# METROPOLITAN GOVERNMENT OF NASHVILLE AND DAVIDSON COUNTY

## STAFF RECOMMENDATION 2819 Hillside Drive May 21, 2014

**Application:** New construction-infill  
**District:** Hillsboro-West End Neighborhood Conservation Zoning Overlay  
**Council District:** 18  
**Map and Parcel Number:** 10410022000  
**Applicant:** Franz Baudenbacher  
**Project Lead:** Robin Zeigler, robin.zeigler@nashville.gov

**Description of Project:** The project is for a new two-story home with a front-loading garage to replace a house that was demolished prior to the establishment of the extension of the overlay.

ROOF PLAN

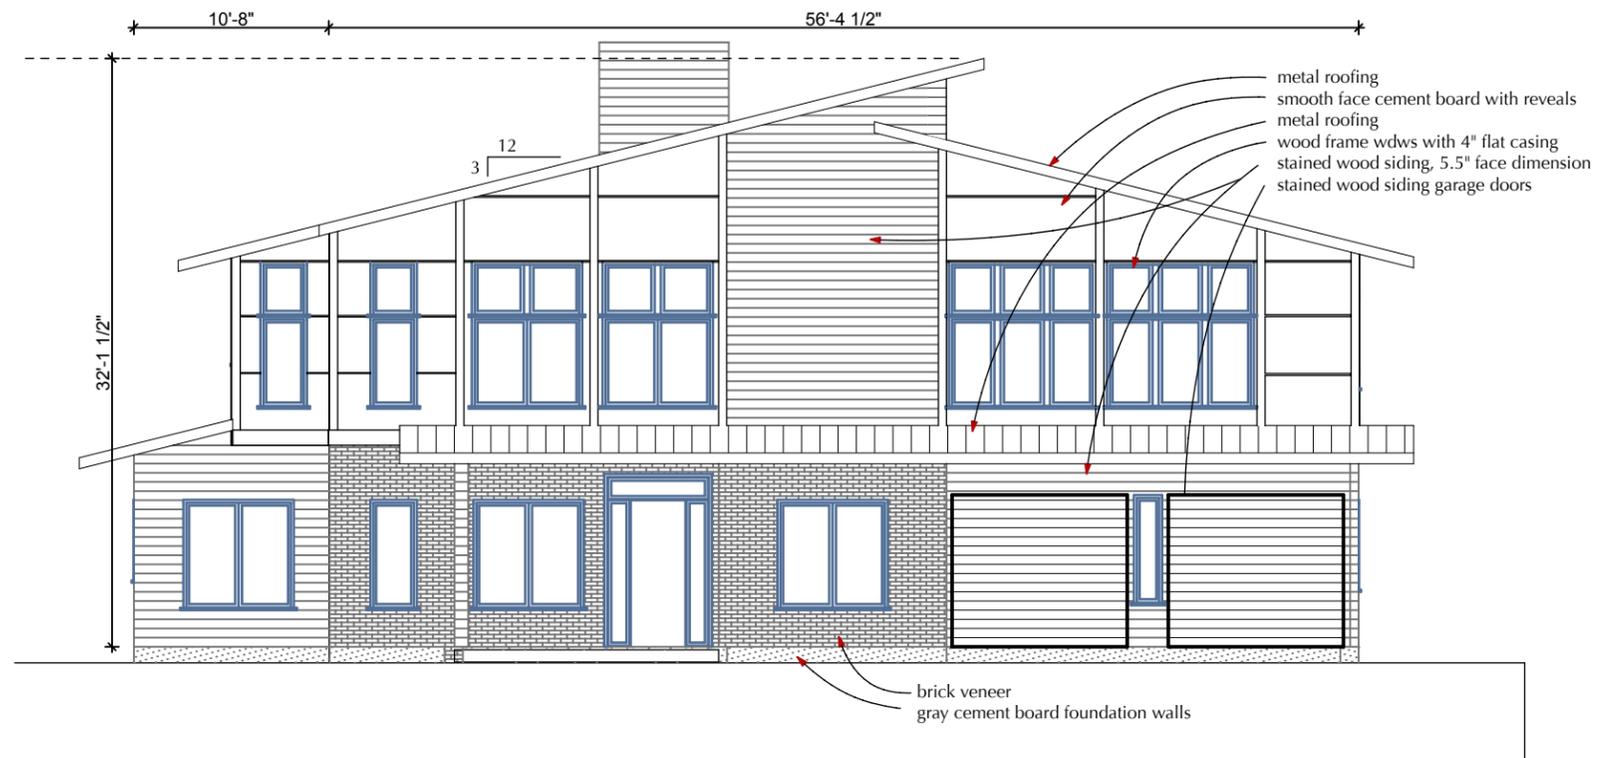
**Roof form:** The applicant proposes a deconstructed front-gable roof form that is not seen in the overlay. The Commission approved a deconstructed cross-gable form in a different neighborhood, but after construction, decided that it did not meet the design guideline’s requirement that roof forms for new construction be “visually compatible, by not contrasting greatly, with the roof shape, orientation, and pitch of surrounding historic buildings.” The Commission expressed its interest in not approving these forms in the future and typically directs applicants to match an existing form in the district. Prevalent roof forms found in the district include cross gable, side gable, and hipped forms.

Two-story building forms typically have a side-gable roof form, in this portion of the district. Based on the fact that roof forms should be visually compatible with historic roof forms and should not contrast with these forms, the project does not meet section II.B.1.e.

- The front setback be in keeping with the two closest historic buildings on either side of the lot.
- The roof form be redesigned to be a side-gable form;
- The utilities located at the rear or on either side, beyond the midpoint of the house;
- The central portion of the second floor and the garage on the first floor have openings to match the rhythm of openings on historic buildings in the district; and
- A walkway should be included leading from the front porch to the street.

**1** FRONT ELEVATION  
SCALE: 1" = 10'

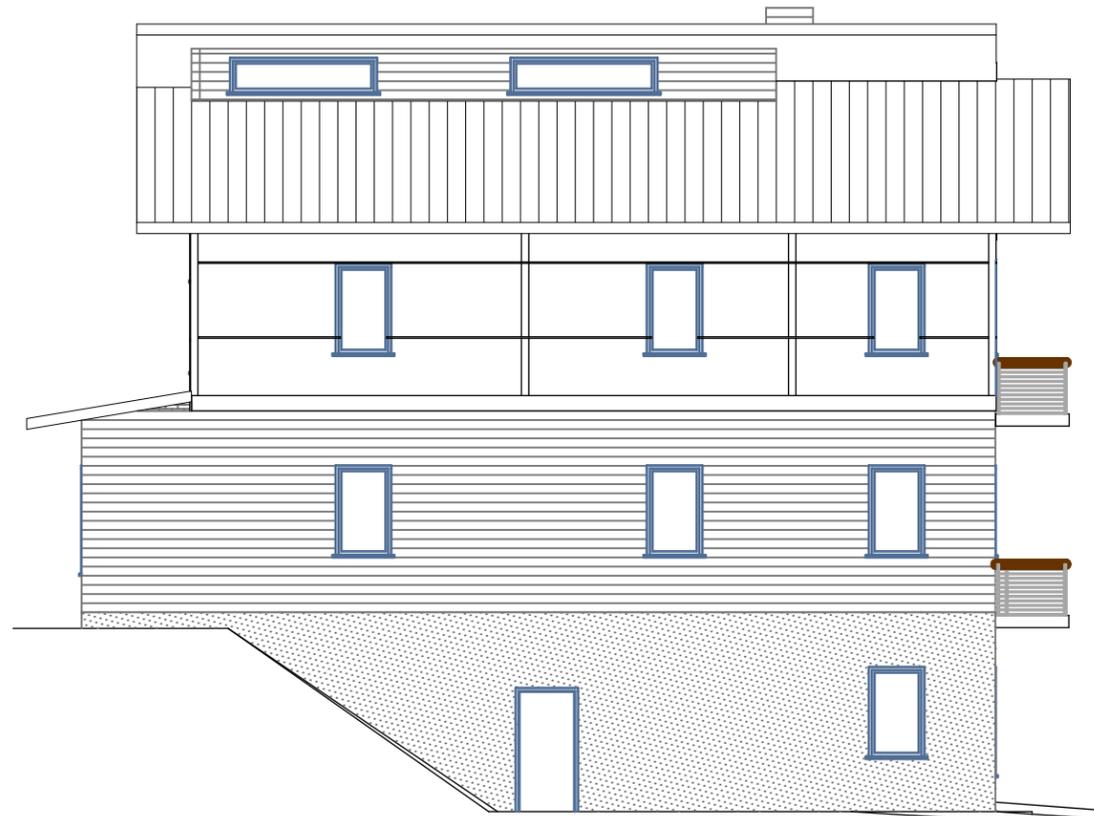
**Height & Scale:** The home is two-stories, as seen from the street, compared to the majority of homes on Hillside which are one or one and one-half stories. The height of the building, at its tallest point is thirty-two feet and one and one-half inches (32' 1 ½") from

finished floor. The majority of homes are approximately eighteen to twenty-five feet (18'-25') from grade with two in the immediate vicinity which are approximately thirty-three feet (33') tall from grade. The foundation on the front façade is minimal and gains in height as the grade drops, which is similar to other homes in the district.

The proposed home is sixty-seven feet (67') wide compared to other homes in the vicinity that range between forty-eight to fifty-five feet (48'-55) in width.

The project does not meet section II.B.1.a.and b as the height and width is not similar to the historic context..

Materials: The foundation is proposed to be gray cement board; the cladding e brick, stained horizontal wood siding and smooth face cement panels; and the roof metal. Typically primary material changes happen on historic buildings horizontally, rather than vertically, as seen on this proposal. The first level has a central brick section and horizontal boards on either side. On the second floor, the material is primarily panels with a central section of stained horizontal board. Also, historic wood is usually a smooth-finished painted wood rather than a raw surface with stain. Although a similar material has been used as an accent material, it has not yet been approved as a primary cladding. Staff recommends that there be just two materials, that change between the floors and that the wood be a smooth-finished painted wood, unless it is just used as an accent material. In addition, minimally the ground floor should be brick as all the homes on Hillside are brick. The windows are proposed to be wood and the doors are not indicated with the exception of the garage doors which will be wood horizontal siding. The chimney and porch materials are not indicated. There are no known metal roofs in the district, so the material is inappropriate. The driveway will be grass pavers. The known materials do not meet section II.B.1.d

Proportion and Rhythm of Openings: There are two locations on the front of the building that are large blank spaces, not meeting the rhythm of openings seen historically. One such section is on the central portion of the second level which is approximately twelve and one-half feet (12' ½") wide and the other is the garage on the first level, which is approximately twenty-two feet and six inches (22' 6") wide. The front facades of historic homes typically have windows every eight to ten feet (8'-10'). Although the central section is close to meeting appropriate rhythm, its central location and prominence as the tallest and most forward portion of the building keep it from matching the historic context. The proportion of windows is appropriate but the rhythm of openings is inappropriate. The project does not meet Section II.B.1.g because it does not maintain the rhythm of openings found on the historic buildings.

- The total width of the building be approximately fifty-five feet (55');
- The foundation material be masonry, rather than just a stucco board;
- The primary veneer for the home be brick;
- The roof be asphalt shingle with the color to be approved by staff;
- The chimney be a masonry material;
- All window and door designs and materials be approved by staff;
- There be just two primary cladding materials, that change between the floors and that the wood be a smooth-finished painted wood, unless it is just used as an accent material.
- All materials that are not indicated be approved by staff;
- The garage be located at the basement level on the side or rear of the building or be detached and located towards the middle to rear of the lot;
